Access Compliance Report

Public Rights-of-Way

(Curb Ramps)

Intersection ID: 11323	Main Street: AIRLIE_ST	Cross Street: SHAMROCK_DR	Location: SE
ADA ID: CC5A74B162E2	Ramp Type: Perp	Initial Pass/Fail: Fail	Overall Compliance: No
Severity Score: 10			
Codes/Mitigation Info/Possible Solution		Field Measurements/Component Compliance

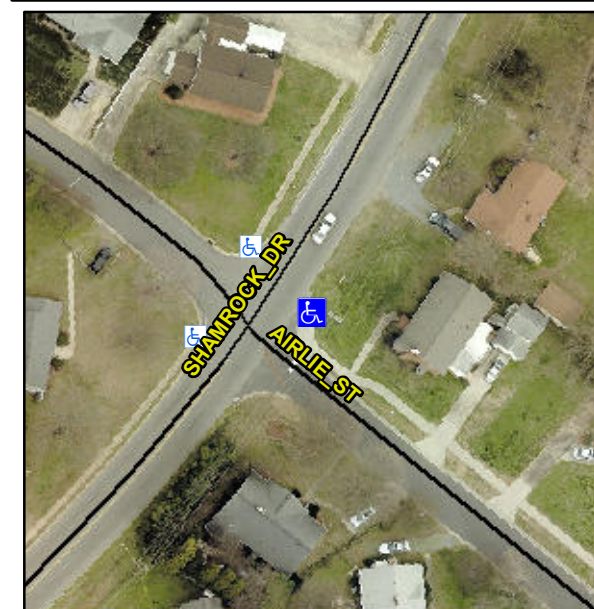
Not Found, R304.5.1, R304.5.3

Compliance	Description	Data	Compliance	Description	Data
N/A	Ramp Length (in)	36.0	Yes	Ramp Slope (%)	5.7
No	Ramp Width (in)	47.0	No	Ramp XSlope (%)	2.3
N/A	Flare Type LT	N/A	N/A	Flare Type RT	N/A
N/A	Flare Slope LT (%)	N/A	N/A	Flare Slope RT (%)	N/A
N/A	Flare Traversable LT?	N/A	N/A	Flare Traversable RT?	N/A
N/A	Landing Length (in)	N/A	N/A	DWS Provided?	N/A
N/A	Landing Width (in)	N/A	N/A	DWS Contrast?	N/A
N/A	Landing Slope (%)	N/A	N/A	DWS Length (in)	N/A
N/A	Landing X Slope (%)	N/A	N/A	DWS Full Width?	N/A
N/A	Landing Curb? (Y/N)	N/A	N/A	DWS Offset (in)	N/A
N/A	Shared Landing?	N/A			
N/A	Gutter Ponding?	N/A	N/A	Gutter Slope (%)	N/A
N/A	Gutter Lip Ht (in)	N/A	N/A	Gutter X Slope (%)	N/A
N/A	Painted X Walk1?	No	N/A	Painted X Walk2?	N/A
	X Walk 1 Direction	To NW		X Walk 2 Direction	N/A
N/A	X Walk 1 Width (in)	N/A	N/A	X Walk 2 Width (in)	N/A
	X Walk 1 Slope (%)	0.6		X Walk 2 Slope (%)	N/A
	X Walk 1 X Slope (%)	1.3		X Walk 2 X Slope (%)	N/A

Remove & Replace Entire Ramp.
